| Project: | Wollongong Central and West Keira Development | Job No: | 60219101 |
| Subject: | Modification 4 - Response to Council Comments | | |

West Keira Redevelopment – Proposed Modification

Figure 1: Proposed Vehicle Access Building Alignment

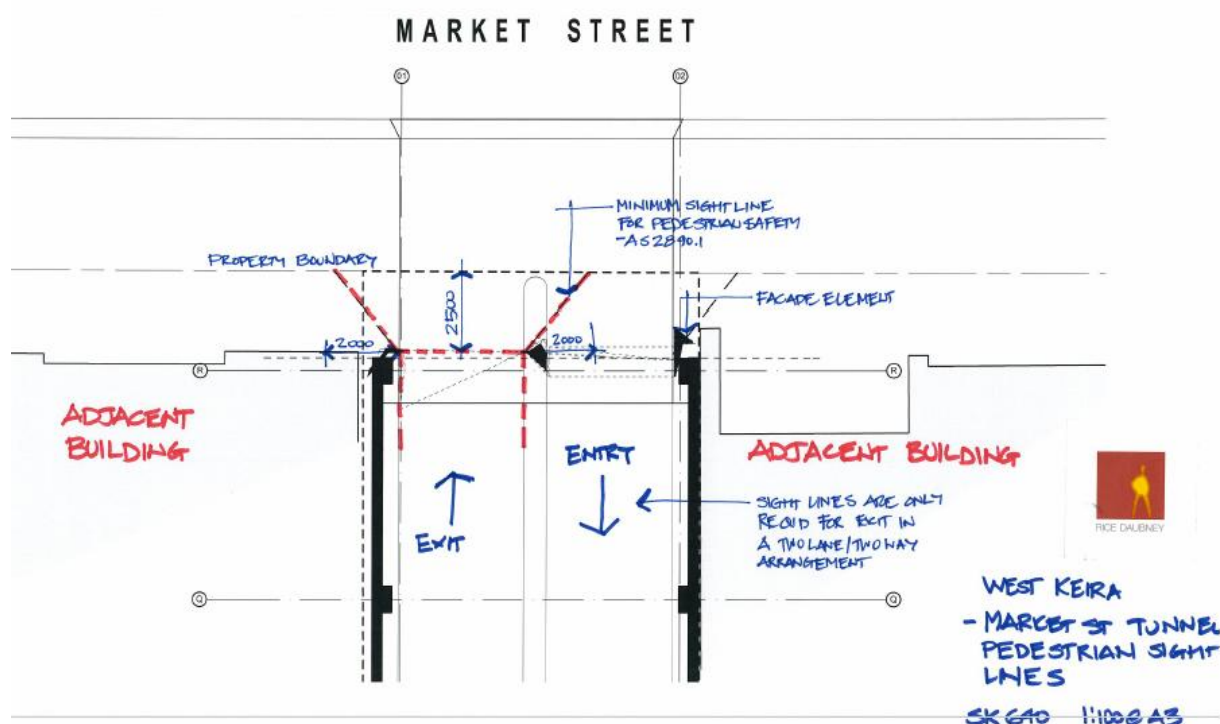
The proposed new access crosses the footpath in a busy pedestrian area. Pedestrians have the right of way under these arrangements so it is important that the development provides at least minimum pedestrian sightlines for pedestrian safety in accordance with AS2890.1 Figure 3.3. However the required sight triangles do not appear to have been provided on either side of the access, and a central column is shown within the access which would also obstruct a driver's view of pedestrians.

It is noted that the vehicle access point is set back from the property boundary as shown in Figure 1, by approximately 2.5m. This ensures the structural elements of the development do not obstruct the minimum required sight lines to the footpath edge.

As shown in the figure above, the sight triangle will be provided on the eastern side. On the western side, it is noted that the required sight triangle is, in part, within the adjoining property boundary. Figure 2 below further demonstrates how visibility of pedestrian movements is maximised across the access.

Figure 3: Proposed Traffic Facilities Adjacent to the Exit Ramps at Market Street

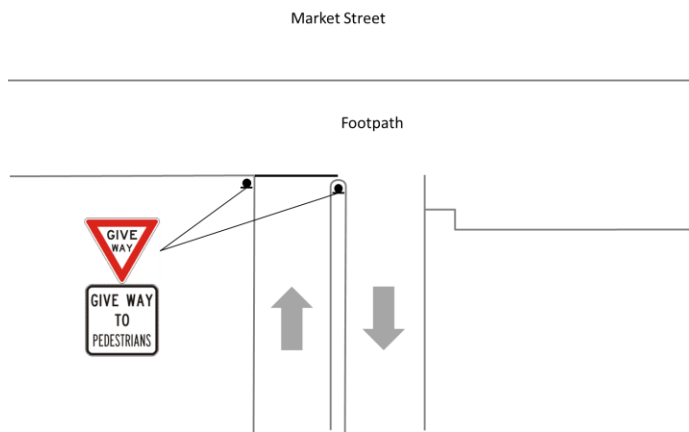
Cars exiting the site, particularly right-turns, may need to wait on the footpath obstructing pedestrian flow, This would result in potential pedestrian/vehicle conflicts as pedestrians are likely to walk in front of or behind cars while drivers look for gap in traffic. Drivers may suddenly exit once a gap in traffic emerges without seeing approaching pedestrians.

Appropriate signs and linemarking would be installed at the exit onto Market Street. Cars stopped at this location would have sufficient visibility of vehicles along Market Street. The traffic facilities would be positioned as such that motorists would not need to protrude onto the footpath and the vehicle will remain positioned within the property boundary, as shown in Figure 3.

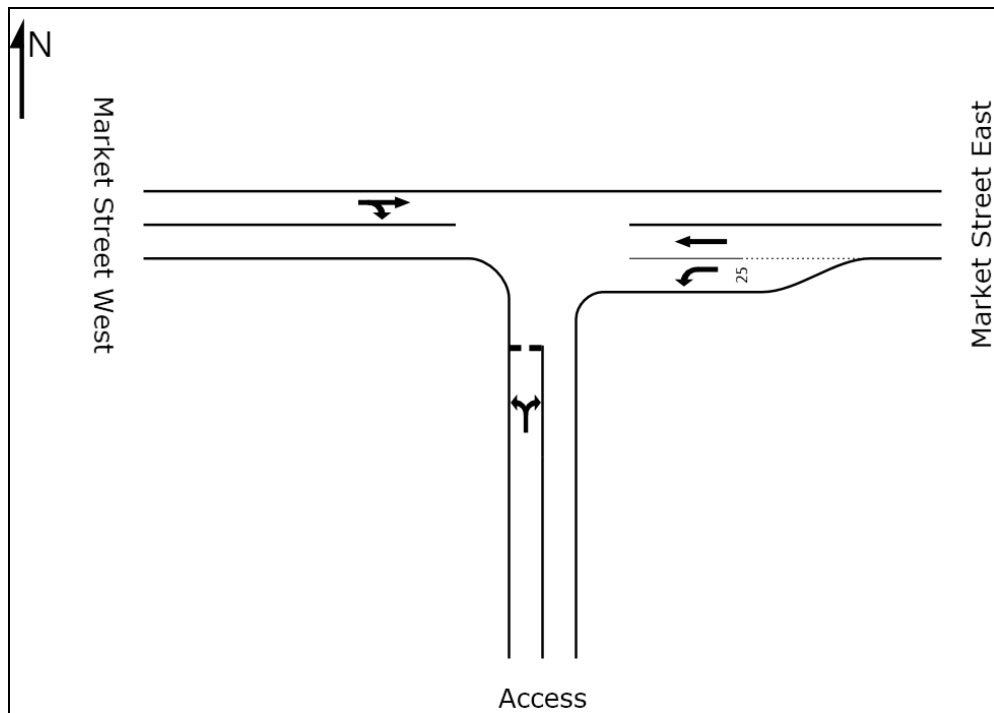
Clarification should be sought to confirm that the on-street parking on the northern side of Market Street opposite the driveway, has been considered 'fully parked-out' during traffic analysis. This would not allow through traffic to pass vehicles waiting to turn right into the subject development. Council is concerned that the modelling may not have considered this issue.

The SIDRA assessment was undertaken based on the layout shown below:

As shown by the diagram, the assessment was undertaken based on the assumption that all the parking bays opposite the vehicle access are occupied.

The analysis as submitted with Modification No. 4, indicates the access will operate at LoS B under this arrangement, however, if Council is concerned about the traffic capacity impact on Market Street as a result of the modelled access arrangements, the 3 ticket parking spaces opposite the proposed access may be designated as a 'No Parking' zone during the operation of the car park, pursuant to Council approval. This would enable all through traffic to pass vehicles waiting to turn right into the development.
